Access Compliance Report Public Rights-of-Way (Curb Ramps)

Main Street: GILLY_FLOWER_ST		Cross Street: ZINNIA_ST		Location:	NE
ADA ID: RPRK211111140824	Ramp Type: Type 4 - Parallel	Initial Pass/Fail: Fail	Overall Compliance: No	Severity Score:	2
Codes/Mitigation Info/Possible Solution			Field Measurements/Component Compliance

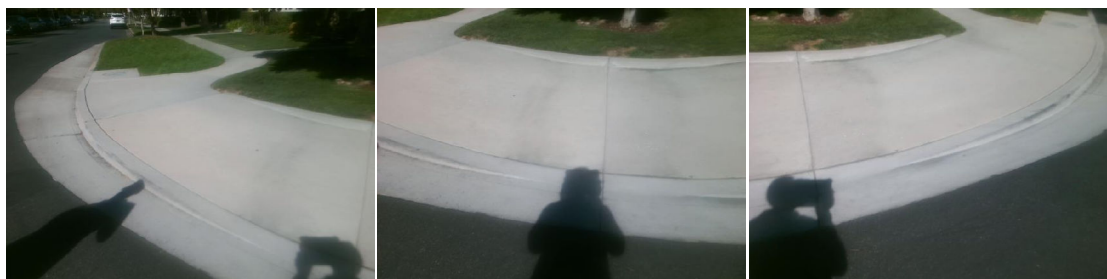
Compliance	Description	Data	Compliance	Description	Data
N/A	Ramp Length LT (in)	132	N/A	Ramp Length RT (in)	133
Yes	Ramp Width LT (in)	90	Yes	Ramp Width RT (in)	90
Yes	Ramp Run Slope LT (%)	4.8	Yes	Ramp Run Slope RT (%)	5.1
No	Ramp Cross Slope LT (%)	4	Yes	Ramp Cross Slope RT (%)	1.9
N/A	Landing Present	N/A	N/A	DWS Provided	N/A
N/A	Landing Length (in)	N/A	N/A	DWS Contrast	N/A
N/A	Landing Width (in)	N/A	N/A	DWS Length (in)	N/A
N/A	Landing Run Slope (%)	N/A	N/A	DWS Full Width	N/A
N/A	Landing Cross Slope (%)	N/A		DWS Offset Type	N/A
N/A	Landing Movement Obstructed?	N/A	N/A	DWS Offset Left (in)	N/A
	Landing Movement Type	N/A	N/A	DWS Offset Right (in)	N/A
N/A	Landing Shared	N/A			
N/A	Clear Space	Yes			
N/A	Clear Space To Crosswalk (in)	N/A			
N/A	Marked Crosswalk 1	No	N/A	Marked Crosswalk 2	No
	Crossing 1 Direction	SW		Crossing 2 Direction	SE
	Marked Crosswalk 1 Width (in)	N/A		Marked Crosswalk 2 Width (in)	N/A

Remove & Replace Curb Ramp With Two New Directional Ramps or Equivalent.
